Technical Information	Date: 12.07.2018 Official: Marier Department: BT-FIR/MKP3
------------------------------	---

Tech. Information No.	2134 / 2017
Subject:	FPA-5000 firmware 2.21.2: LSN module fault message on panel

Short Description:	Fault message in combination with LSN module V1.0.53 and true t-tap topology → "Exchange module now! See TI 2134/2017"
---------------------------	--

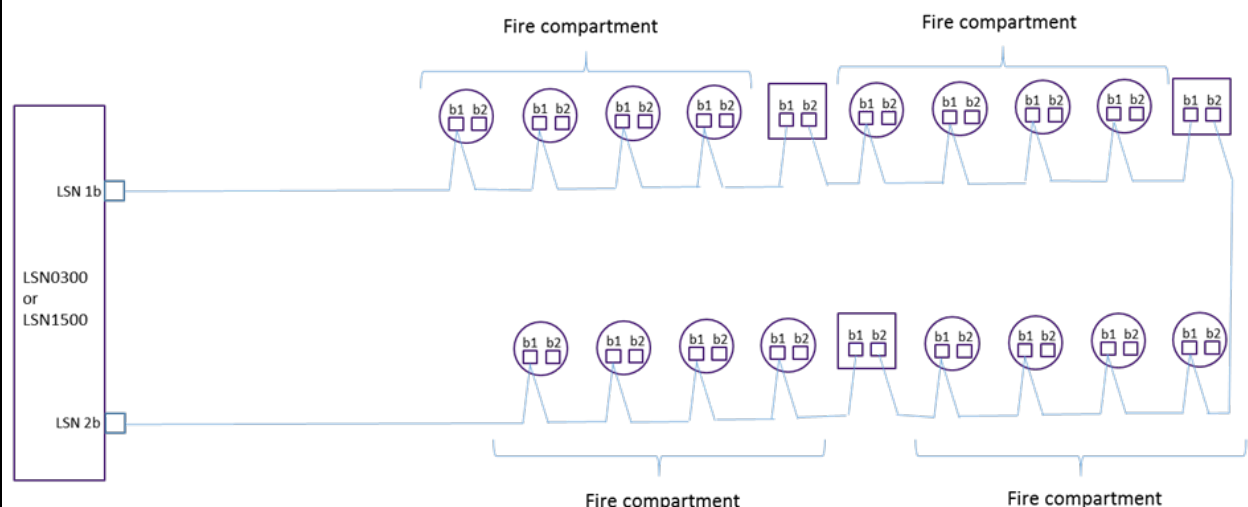
The problem is only occurring on LSN bus systems with manually addressed T-Tap topologies (mixed-topology or stub)!

In RPS the topology tree needs to be like shown in the picture below:

“True T-tap” means that the isolator function of the LSN elements is not used. In T-tap configurations the b-wires of the LSN-bus are only connected to one of the the b-connectors of the devices (e. g. b1). See example (round elements) below:

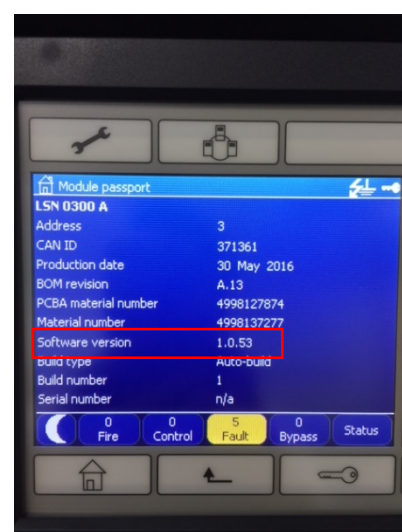
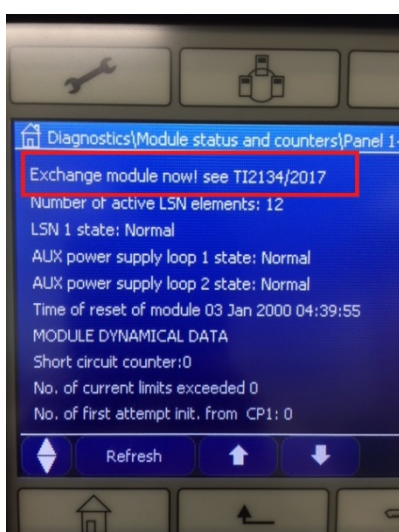
All customers (except in HK) who use manual addressing of detectors with true T-TAP topologies:
With MPC firmware V2.21.2 we have implemented a check to identify affected installations.

In case you have true T-tap topologies in your system and LSN modules with firmware V1.0.53 you will get a fault message as shown below:

In case your system is affected please provide photos of the fault messages on the MPC screen (similar to above) to ASA referring to TI 2134/2017.

You will then receive a replacement for the affected LSN modules.
